Agenda Item	6.3
Report No	PLS-059-20

## HIGHLAND COUNCIL

**Committee:** South Planning Applications Committee  
**Date:** 08 December 2020  
**Report Title:** 20/01714/FUL: Mr James Macnaughton  
Glenmamie, Lochailort, PH38 4NA  
**Report By:** Area Planning Manager – South

**Description:** Change of use to site 4 holiday letting pods and parking  
**Ward:** 11 – Caol and Mallaig  
**Development category:** Local  
**Reason referred to Committee:** Member Request for Referral

detail: O1-Site  
Site Plan Proposed

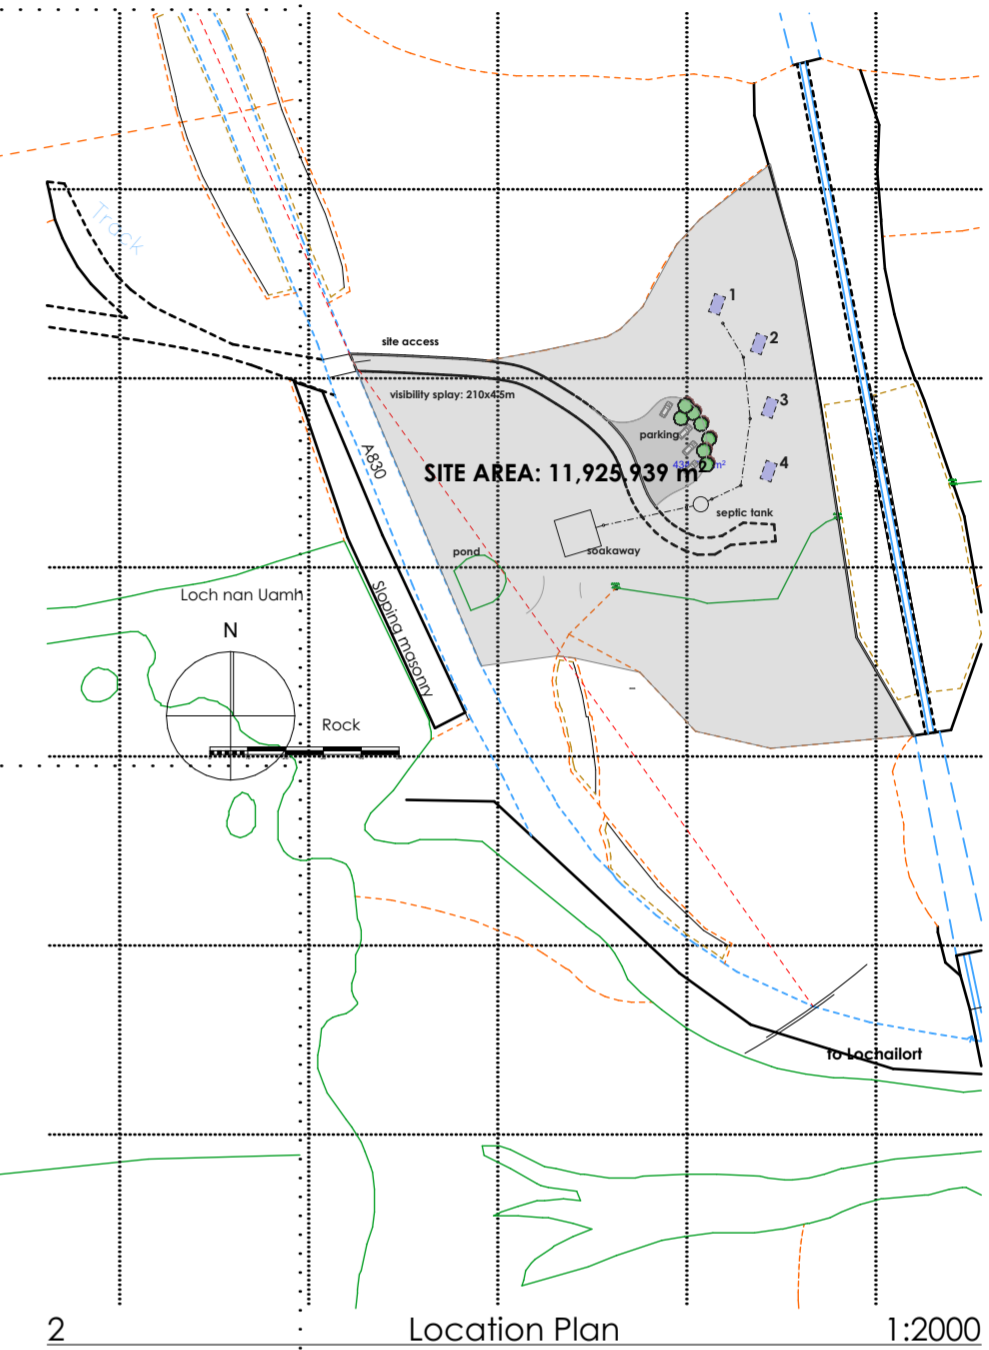
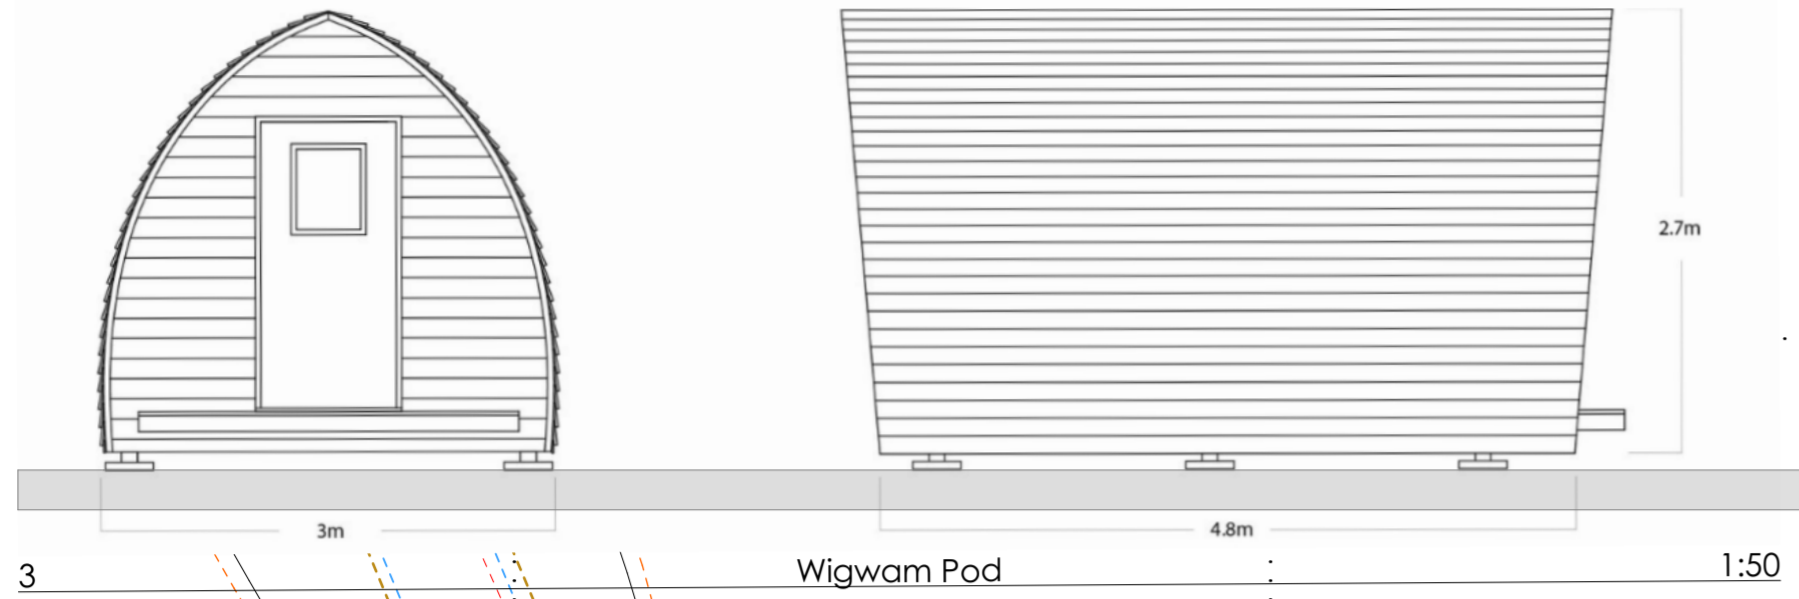
The proposed access is substandard and would create interference with the safety and free flow of traffic on this length of trunk road where vehicle speeds are high.

The visibility splays as required by DMRB CD123 are not achievable from the access point onto the A830. This constitutes a safety risk to vehicles on the trunk road.

- 8.12 Transport Scotland has raised concerns that the proposed access is substandard and would create interference with the safety and free flow of traffic on this length of the trunk road where vehicle speeds are high.
- 8.13 Transport Scotland advise the visibility splays required by Design Manual Roads and Bridges CD123 are not achievable from the access point onto the A830. This constitutes a safety risk to vehicles on the trunk road.
- 8.14 The visibility splays shown on the layout plans submitted show a visibility splay of 4.5m x 210m to the south east. There is a rock cutting to the south of the existing access which obstructs visibility in this direction. An assessment of the splays on

site suggested a splay of approximately 130m to the south east and approximately 200m to the north west. Given the rocky topography it appears unlikely that the visibility splays shown on plan would be feasible on site.

9.2 Unfortunately, the proposed pod site would be served by an existing substandard access onto the trunk road. Given the rock cutting to the south east of the access, which represents a significant obstruction to advance visibility, it appears there is little scope to achieve appropriate advance visibility and safe access. There are no footways or formal crossing facilities in the vicinity of the site and pedestrian movements represent a road safety concern. The safety of users of the site, access and trunk road is paramount, and the proposal does not meet the requirements of policies 28, 36, 44 and 56 of the Highland wide Local Development Plan, 2012.

1. The proposal would be served by a substandard access onto the trunk road and fails to comply with the Design Manual for Roads and Bridges for the formation of the access meeting required visibility splays. The proposal would have an adverse impact on the safety and flow of traffic on the trunk road network, contrary to policies 28, 36, 44 and 56 of the Highland wide Local Development Plan, 2012.
2. The proposed development would be located adjacent to a high speed section of the trunk road where there are no footways or formal crossing facilities. Increased pedestrian activity in the location would have an adverse impact on the safety and flow of traffic on the trunk road network, contrary to policies 28, 36, 44 and 56 of the Highland wide Local Development Plan, 2012.
